**SUBDIVISION,  
PLANNED UNIT DEVELOPMENT, &  
ZONING AMENDMENT STAFF REPORT****Date: November 5, 2020****APPLICANT NAME**

The Hive Subdivision

**LOCATION**5377 Moffett Road  
(South side of Moffett Road, at the North terminus of  
McIntyre Drive).**CITY COUNCIL  
DISTRICT**

Subdivision Approval to create one (1) lot of record from a single metes-and-bounds parcel; *Planned Unit Development approval to allow multiple buildings on a single building site*; and Rezoning from R-1, Single-Family Residential District to B-1, Buffer Business District.

# SITE PLAN

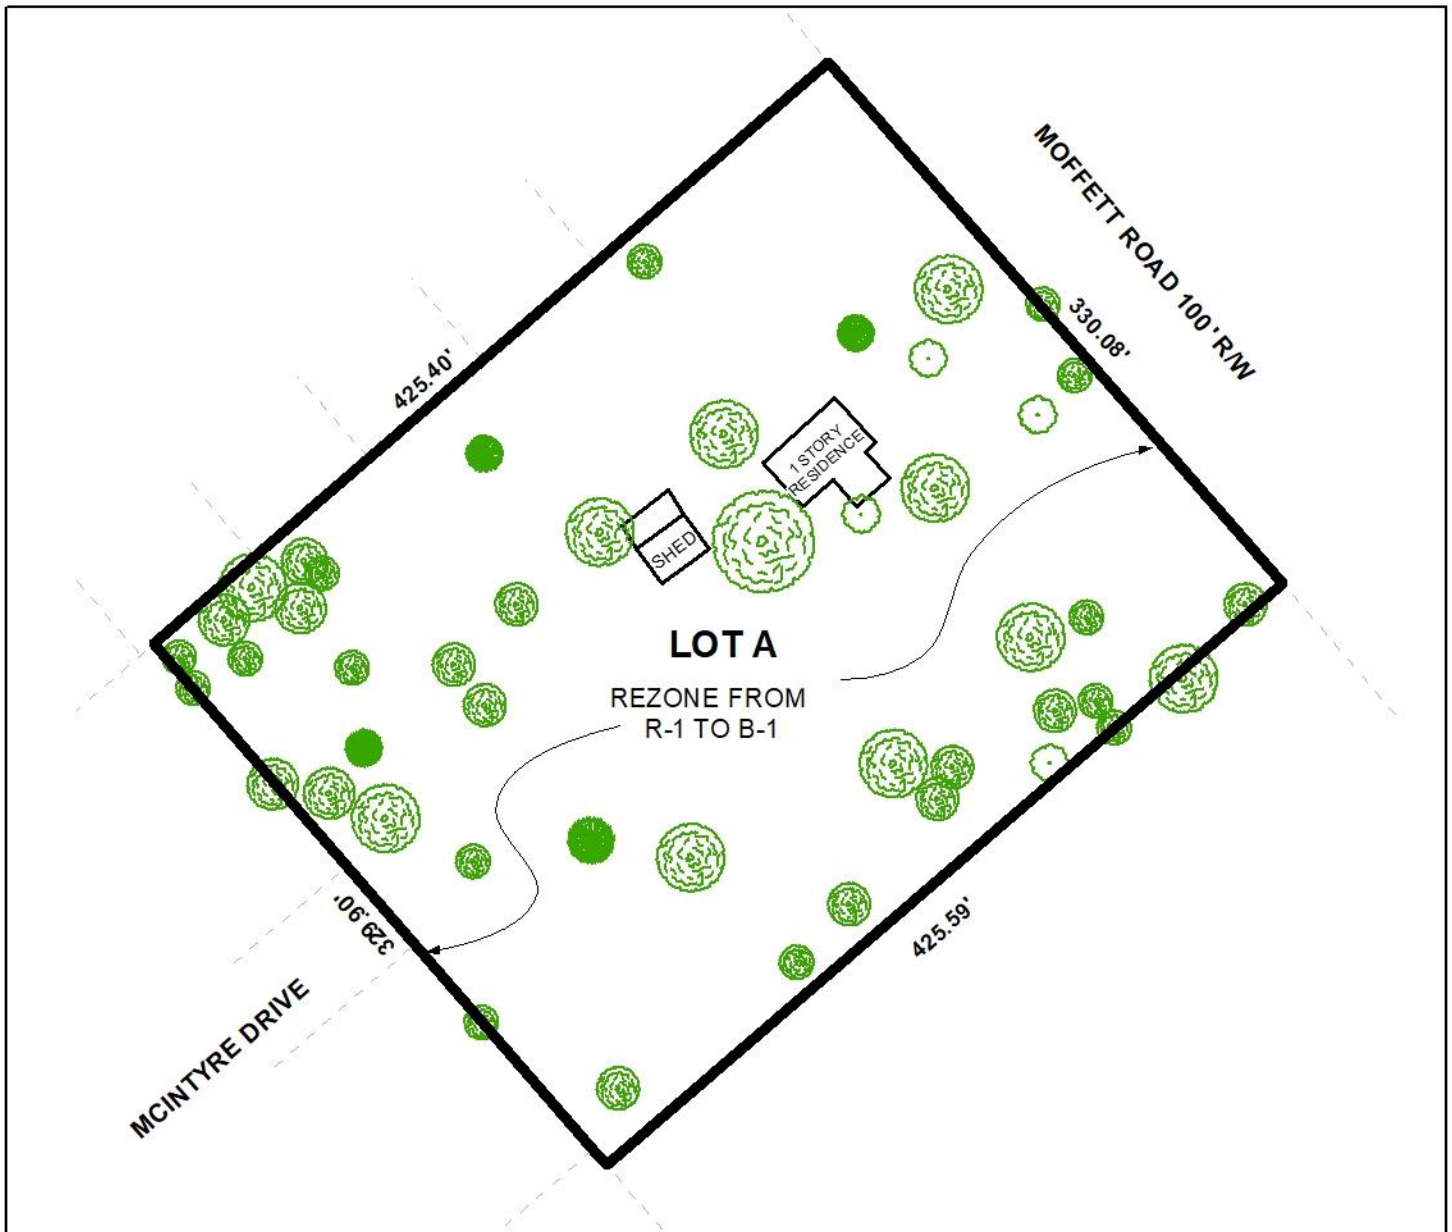
The applicant proposes to create one (1) lot of record from a single metes-and-bounds parcel. The lot size is depicted in square feet and acres on the plat and exceeds the minimum lot size requirements of Section V.D.2. of the Subdivision Regulations. If approved, the lot size should be retained in square feet and acres on the Final Plat.

The site has frontage along Moffett Road and McIntyre Drive. Moffett Road is a major street, depicted as having a compliant existing right-of-way of 100-feet, making no dedication necessary. McIntyre Drive dead-ends into the "rear" of the property; while it is not depicted on the preliminary plat, it is a minor street with curb and gutter, and therefore should have a 50-foot wide right-of-way. If approved, the Final Plat should be revised to label the rights-of-way for both street frontages.

The preliminary plat does not illustrate the 25' minimum building setback lines from either frontage. If approved, the plat should be revised to depict the 25' minimum building setback lines on both frontages.

The site appears to have one (1) existing curb-cut to Moffett Road. The applicant is requesting a curb-cut each to Moffett Road and McIntyre Road. If approved, the Final Plat should include Traffic Engineering comments regarding access to the site.

*It should be noted that the site plan has a few minor corrections that must be made. First, the site plan incorrectly identifies the side and rear setbacks for the property as being eight (8) feet, when it should be ten (10) feet where adjacent to residential, and five (5) feet where adjacent to commercial. Also, there is a note stating "max building height: 25'-9""", which seems to be the height of the proposed structures, rather than the maximum building height allowed in either a B-1 or R-3 district. If approved, the note should be revised to state "Max proposed building height".*

*The site plan and subdivision plat indicate that there is to be no access to McIntyre Drive. If approved, these notes should be retained.*

*A sidewalk is depicted along Moffett Road, and should be provided along McIntyre Road as well, if approved.*

- 1) retention of the lot sizes in square feet and acres;
- 2) revision of the Final Plat to label McIntyre Road and its right-of-way width;
- 3) revision of the plat to depict the 25' minimum building setback lines along both street frontages;

- 1) retention of the lot sizes in square feet and acres;*
- 2) revision of the Final Plat to label McIntyre Road and its right-of-way width;*
- 3) retention of the note stating there will be no access to McIntyre Drive;*

- 4) retention of the 25' minimum building setback lines along both street frontages;*
- 5) removal of the zoning district from the Final Plat;*
- 6) full compliance with Engineering comments: (FINAL PLAT COMMENTS (should be addressed prior to submitting the FINAL PLAT for review and/or signature by the City Engineer): A. Provide all of the required information on the SUBDIVISION PLAT (i.e. signature blocks, signatures, certification statements, written legal description, required notes, legend, scale, bearings and distances) that is required by the current Alabama State Board of Licensure for Professional Engineers and Land Surveyors. B. Provide reference, on the map and the description, to a monumented corner. C. Provide and label the monument set or found at each subdivision corner, including the POC. D. Provide a written legal description and matching bearing and distance labels for the proposed subdivision. E. Provide the missing portion of the subdivision boundary line on the south line. F. Label each Tract as a LOT (LOT 1, LOT A, etc.) G. Show and label each and every Right-Of-Way and easement, including drainage easements H. Provide the Owner's (notarized) signatures. I. Add a note to the SUBDIVISION PLAT stating that as shown on*
